NL-10-093

October 05, 2010

Subject: **Indian Point Nuclear Power Plant Units 2 and 3
Response to Request for Additional Information regarding the Inter-Unit
Spent Fuel Transfer License Amendment Request (TAC Nos. ME1671,
ME1672, and L24299)**
Indian Point Units 2 & 3
Docket Nos. 50-247 and 50-286
License Nos. DPR-26 and DPR-64

Response to Request for Additional Information

Figure 1B: HI-TRAC LS-DYNA Tipover Model – Impact Orientation 2

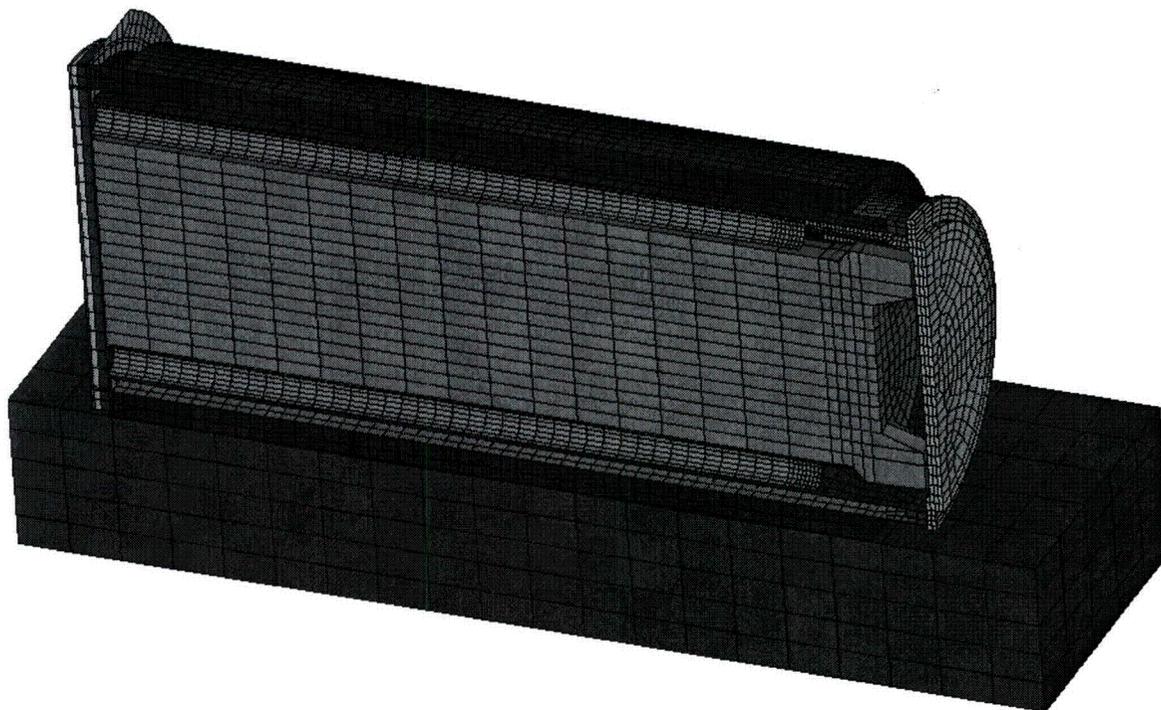
The analyses can be based on a non-mechanistic tipover over the lower corner onto a receiving surface (which bounds the characteristics of the haul path) from a position of balance, with no initial velocity. The analyses should also address confinement integrity, thermal-hydraulic response, gaseous releases from fuel rods, which also affect the internal pressure, and variations in external dose rate and effects on STC emissions during such an event. Although the applicant has identified the crane, airpad, and vertical cask transport systems as components that preclude tipover, analyses are needed to provide defense-in-depth of the safety of the cask transfer system. Additional guidance on acceptable methods of tip-over analyses is provided in NUREG-1536.

If the assessment demonstrates the STC cannot maintain confinement under such an event, the STC should be redesigned such that confinement is maintained. The consequence assessment will provide insights on the level of confidence (including rigor of license condition design controls and operational controls) that is needed to assure that tipover will be precluded (i.e. low likelihood), as currently maintained by the applicant.

To enable the transfer cask to meet the above set of structural criteria, an internal impact limiter has been incorporated in the design. This impact limiter, shown in licensing drawing 7591, consists of an assemblage of aluminum tubes arranged in a weldment configured to occupy the annular space between the STC and the HI-TRAC cylindrical cavity and sized to center the STC inside the HI-TRAC. The thickness of the aluminum tubes was established by iterative tip-over simulations on LS-DYNA.

Figures 1A and 1B show the two limiting configurations considered for the Tip-over analysis. The details of the analysis and corresponding results are presented in Chapter 6, Section 6.2.8.

Figure 3.4-1

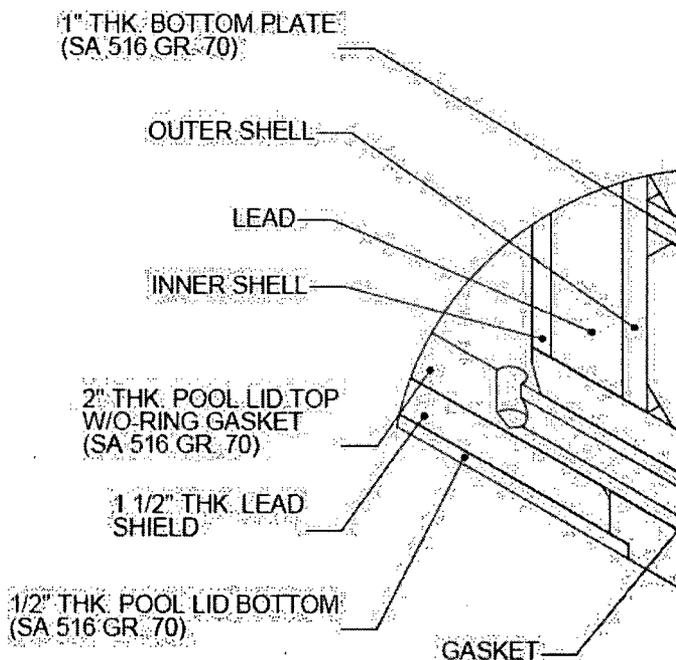
Justify the tornado missile event for the HI-STORM 100 system, as bounding for the IP Fuel Transfer (refer to Table 1.3 in Entergy's Response with Supplemental Information (RSI), dated September 28, 2009.)(SMMB).

Staff notes that the applicant considers that, "ensuring that the annulus water is not lost is a central objective in the system design," as indicated in RSI response 1.b. Analyze the effect on an immobilized STC/HI-TRAC system with a breached outer transfer lid door, and the consequent loss of annulus water if the STC is immobilized outdoors for 30 days due to a transport problem.

HI-STORM 100 FSAR (Revision 4 of Report HI-2002444, Section 3.4.8.2.1) indicates an intermediate tornado missile strike will penetrate through the outer transfer lid door of the base HI-TRAC 100 transfer cask design. Note that this does not indicate that the intermediate missile penetrates through the entire thickness of the transfer lid, only the outer transfer lid door. However, the HI-TRAC 100D used at IPEC does not employ a transfer lid. Instead, the HI-TRAC 100D has a pool lid which performs a dual function in the HI-TRAC 100D design in the dry storage application (see the response to RAI 1-2). Therefore, the missile analysis referred to in this RAI does not apply to the HI-TRAC 100D design.

During the inter-unit fuel transfer, the HI-TRAC 100D will be equipped with the pool lid as indicated on Holtec drawing 4128 Sheet 4. Unlike dry storage cask loading operations, the pool lid remains in place during the entire inter-unit fuel transfer campaign.

To clarify this statement, the pool lid as depicted on Sheet 1 of Holtec drawing 4128 (excerpted in Figure 3.4-1 below) is made of three layers: 1) the “pool lid bottom” made of 0.5 inch thick SA 516, Grade 70 steel plate, 2) a 1.5 inch thick lead plate, and 3) the “pool lid top” made of 2.0 inch thick SA 516, Grade 70 steel plate. The intermediate tornado missile analysis shows that the missile penetrates the pool lid bottom, but it does not penetrate the lead plate and pool lid top. Therefore, a breach of the HI-TRAC 100D pressure boundary due to a tornado missile strike on the pool lid, resulting in a loss of annulus water, will not occur.

It is also important to note that the HI-TRAC 100D when used for the inter-unit transfer, will be equipped with a bottom missile shield (BMS- drawing 7161). The BMS is designed to protect the pool lid flange and lid bolted connection during a tornado missile event. In addition, the BMS will also protect the HI-TRAC 100D drain which will be plugged during the inter-unit transfer. Also, during transfer operations, the orientation of the HI-TRAC 100D and the height of the pool lid from the ground makes a direct missile strike on the pool lid bottom highly unlikely.
